Rev. No.	Description	Date	By	CH'K'D
	REVISED SEPTIC SYSTEM - MULTI-FLO - PER DSMHER	4-5-93	D.A.

SITE PLAN for ROBERT WALKER
TOWNSHIP of LEROY

SITE PLAN

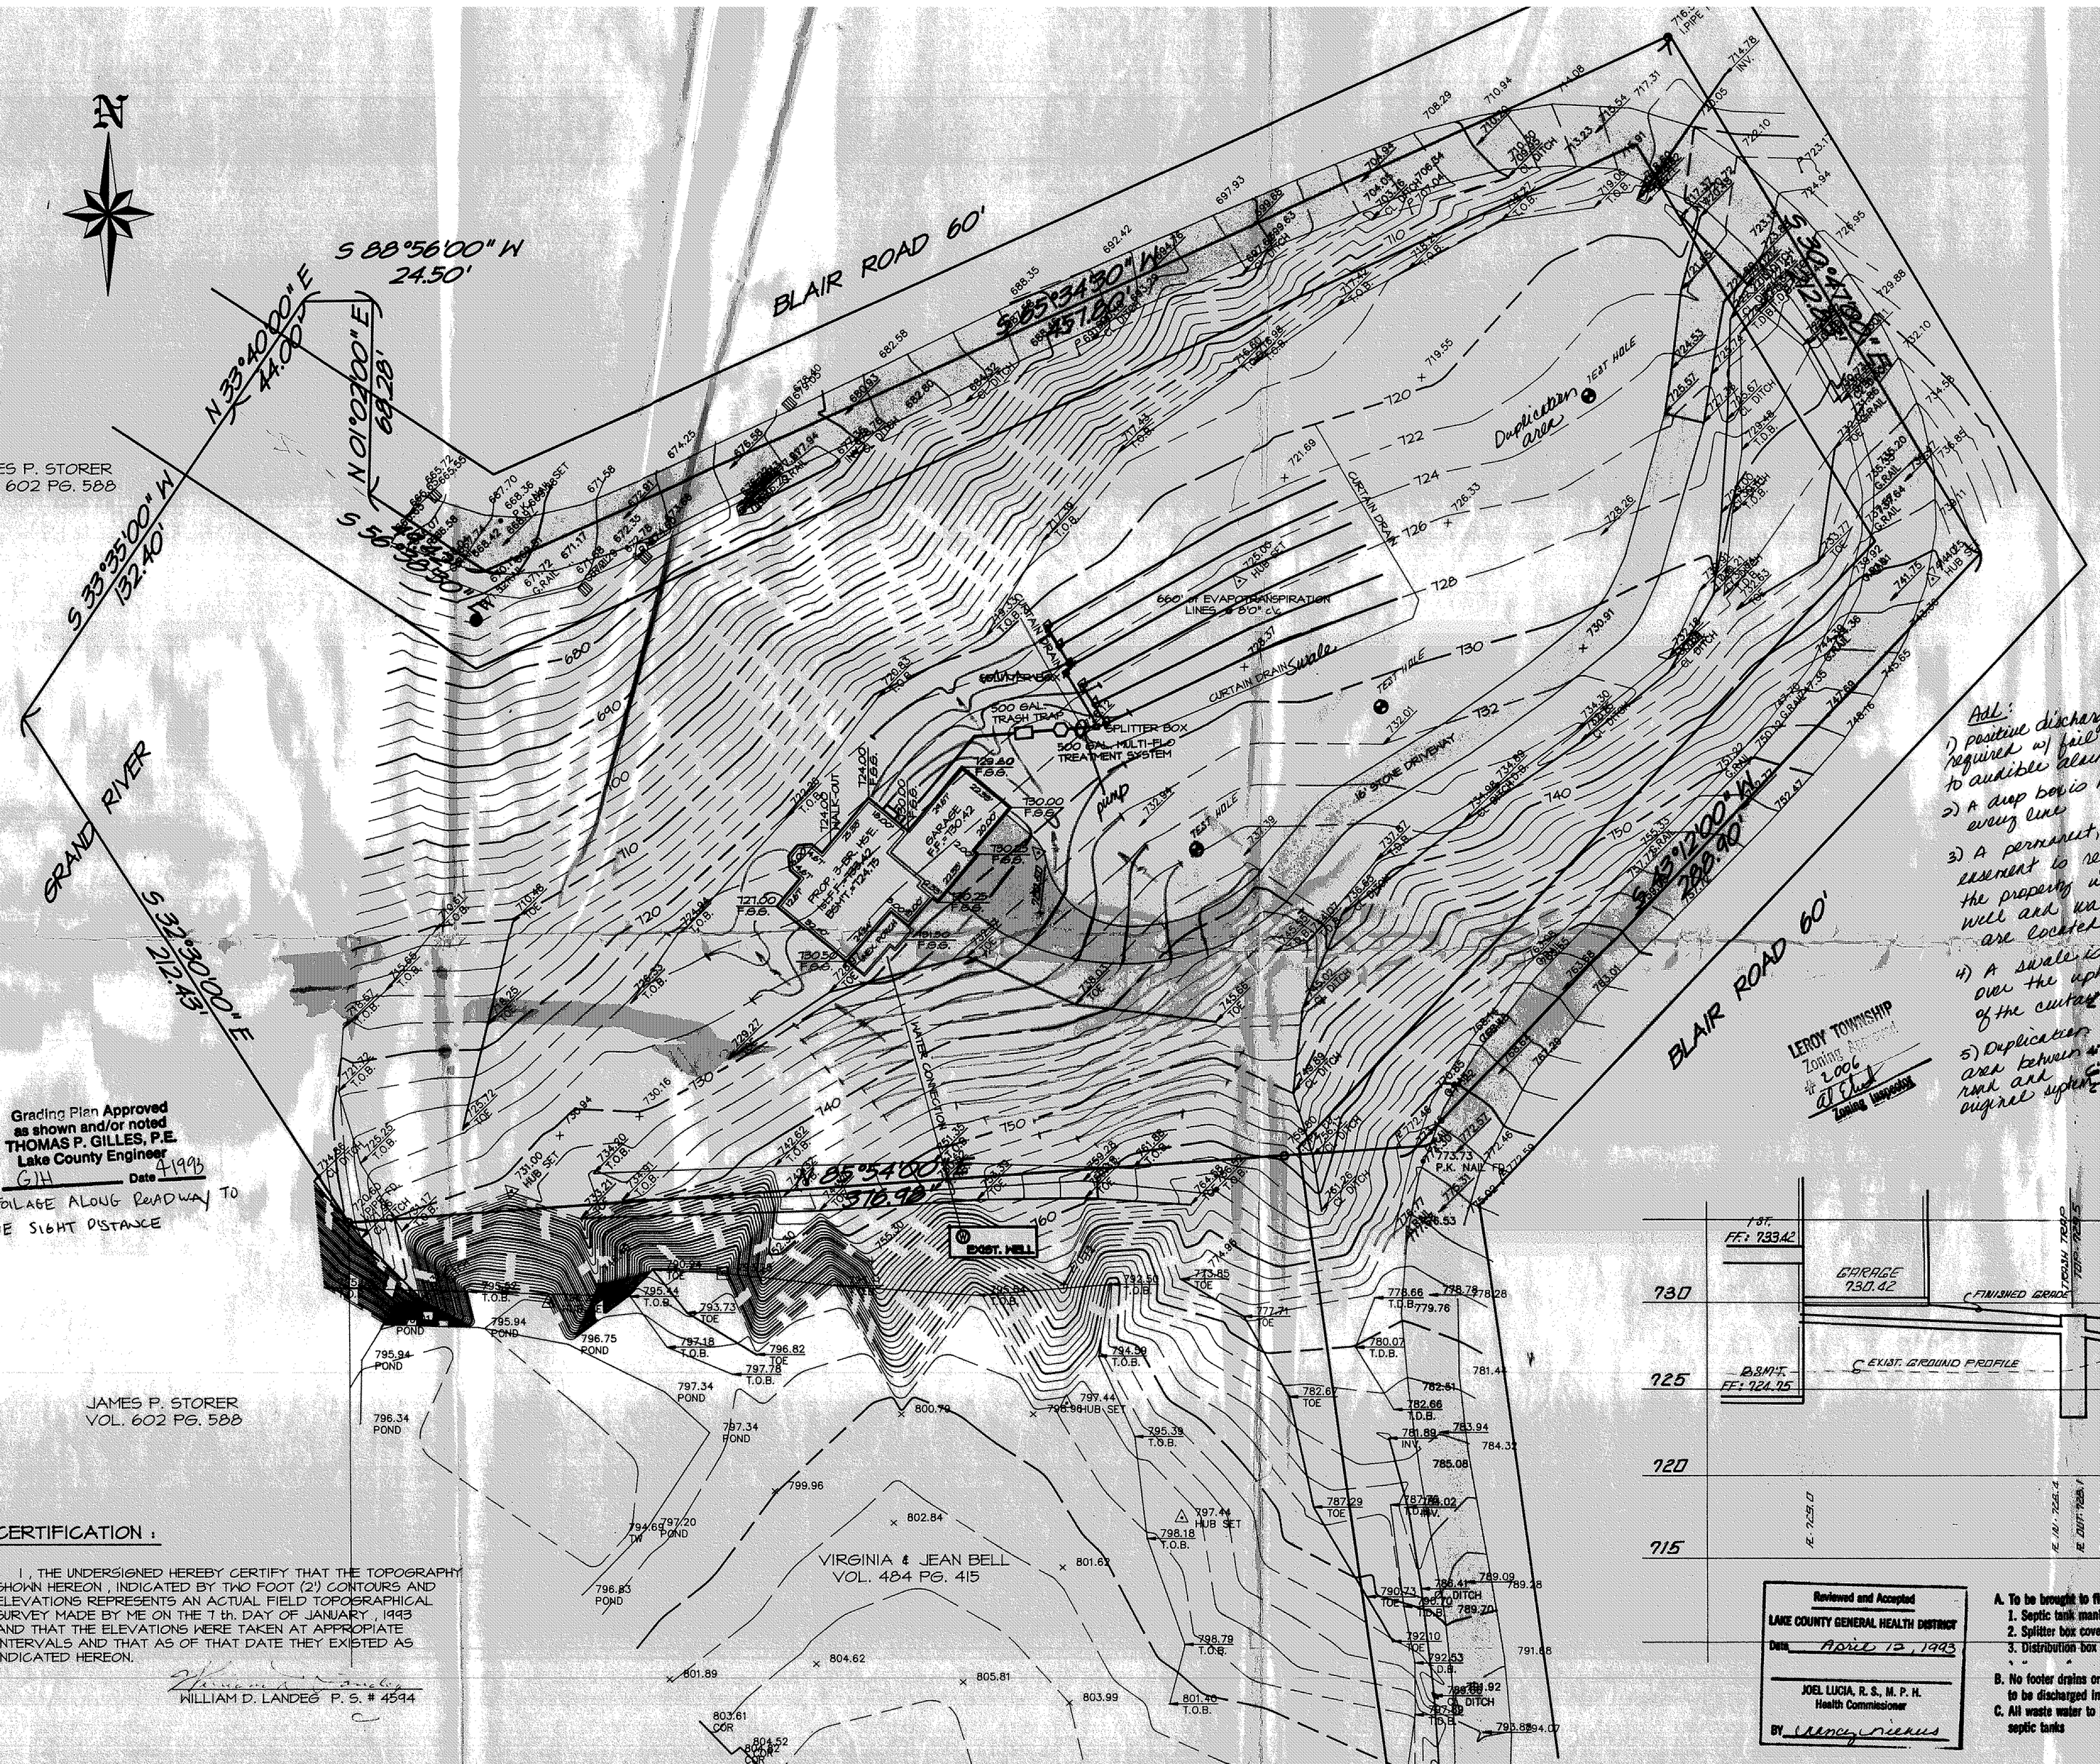
CUT FOLIAGE ALONG ROADWAY TO IMPROVE SIGHT DISTANCE

Add:
1) positive discharge pump required w/ fail safe wiring to audible alarm inside house
2) A drop box is needed on every line
3) A permanent, legal recorded easement to require for the property where the well and water line are located
4) A swale is needed over the uphill side of the curtain drain
5) Duplication area between septic and original system
